Subject: Casandro Wash Dam (07.65)
Application Review Comments
Revised Documents

This letter presents our responses to ADWR's comments included in their letter to the District dated September 27, 1995, for the Casandro Wash Dam project. The comments are from ADWR's review of the following documents:

**Addendum No. 2
Casandro Wash Dam
Final Design Report**

Revised Structural Calculations

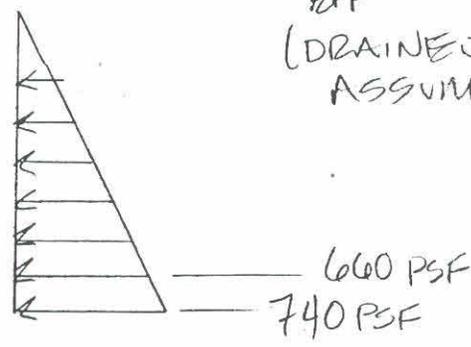
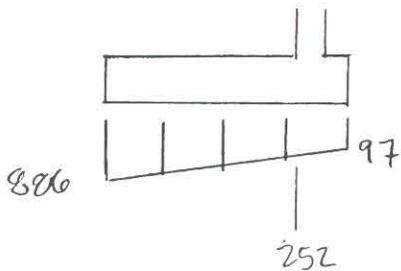
8.A.a. Earth pressures below the footings were calculated for a 1-foot strip as the sum of vertical load divided by footing width (P/A) plus the total applied moment divided by the section modulus (M/S). The total applied moment is the sum of overturning moment due to soil pressure plus the moment caused by the eccentricity of the vertical weight relative to the footing center. This approach is valid only if tensile forces do not develop at either edge of the footing (as is the case for all of the wall sections on the spillway).

It appears that ADWR's confusion is in regard to the eccentricity "e" identified in the structural calculations. The "e" identified in the calculations is the eccentricity of the vertical weight with respect to the center of the wall footing. It is not the eccentricity of the reaction on the footing base. In all cases, the reaction is located in the middle one-third of the footing width.

8.B.a. Refer to the attached calculation Sheets 1 and 1A. The same results are achieved for both calculation methods and the footing steel is adequate as shown on the plans.

asandro Wash Dam ownstream Steady State No Drains
 Ten Most Critical. P:CWD6C.PLT By: DJA 9-19-95 1:21am

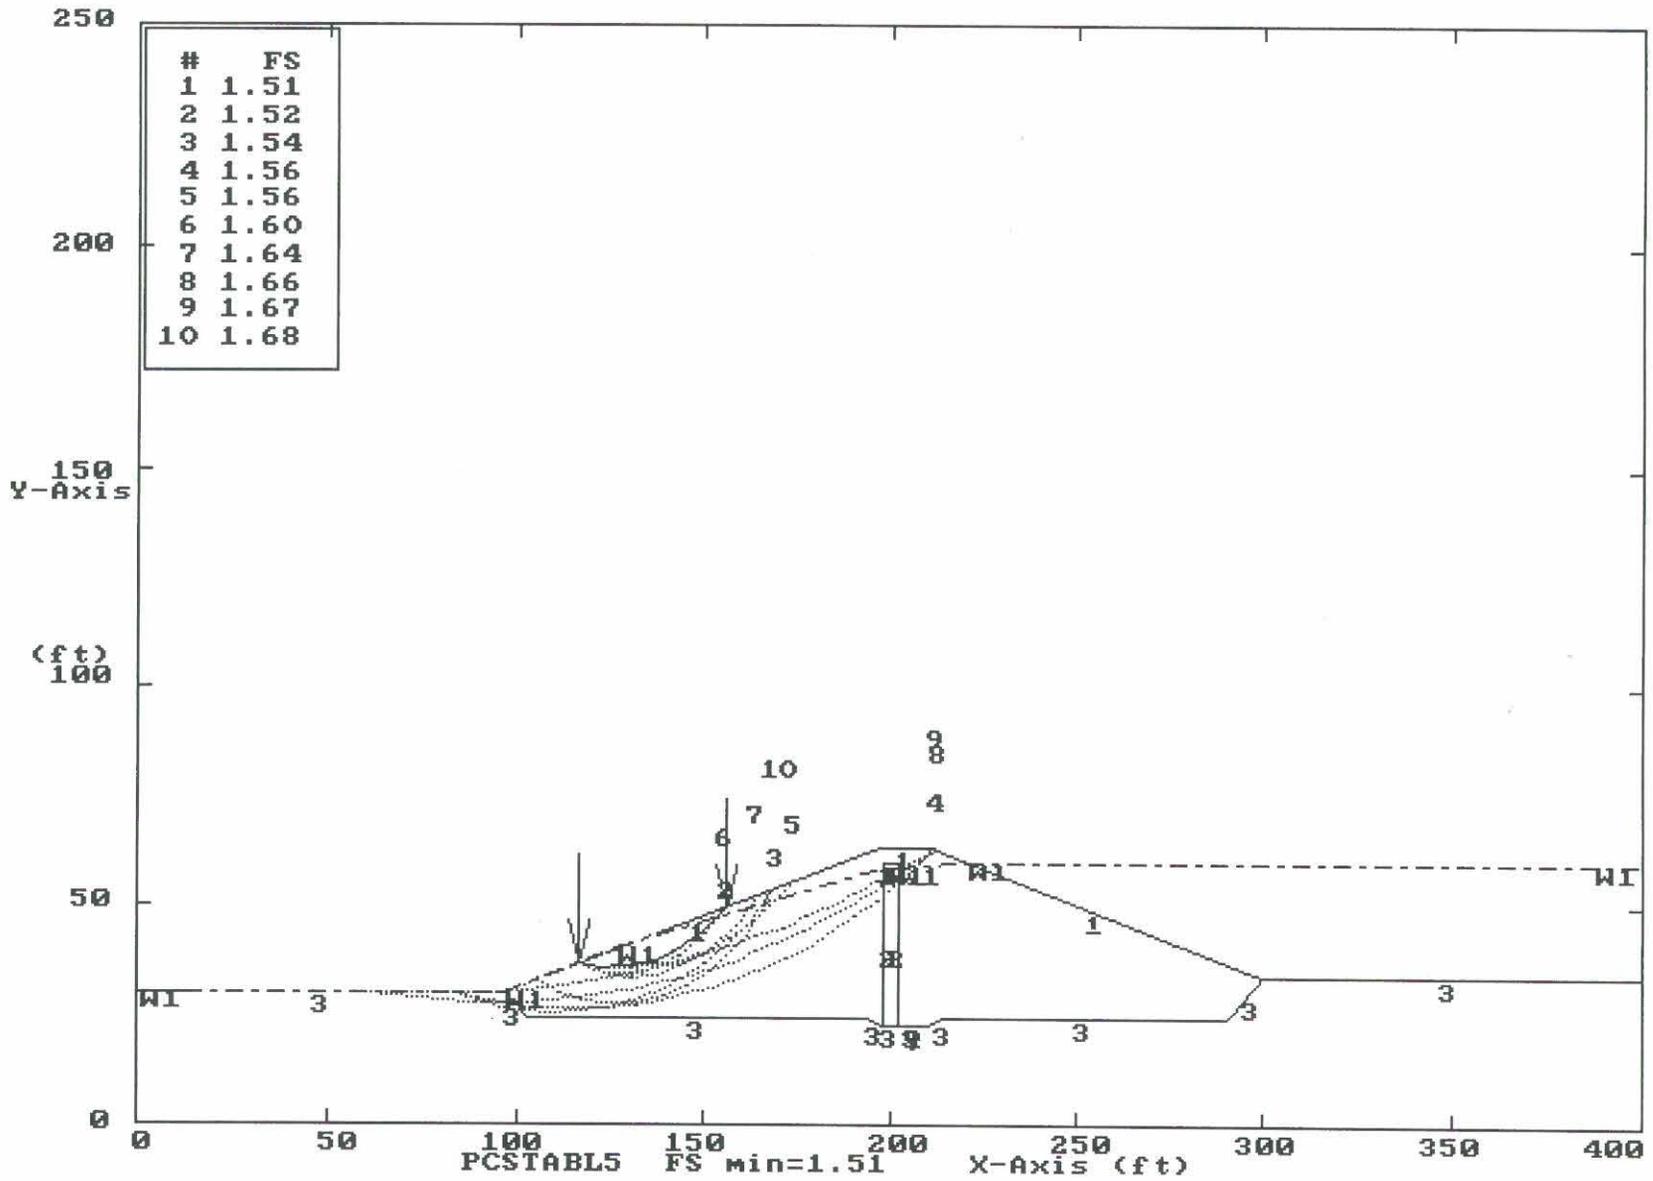
- a. The seepage analysis calculated a seepage rate of 392 gpm. This was calculated based on a steady state seepage condition which requires the reservoir remain at maximum water level for in excess of 10 days. This is a very conservative assumption as the operation of the dam anticipates a full reservoir for less than 1 day. The analysis also used a conservative permeability value of 5×10^{-3} cm/sec. The calculated finger drain capacity is approximately 99 gpm with 10 feet of head.

Should the outlets become blocked and the reservoir stay full until steady state seepage conditions are reached and the drains not function, stability analysis for the downstream slope indicate a factor of safety of greater than the required 1.5.
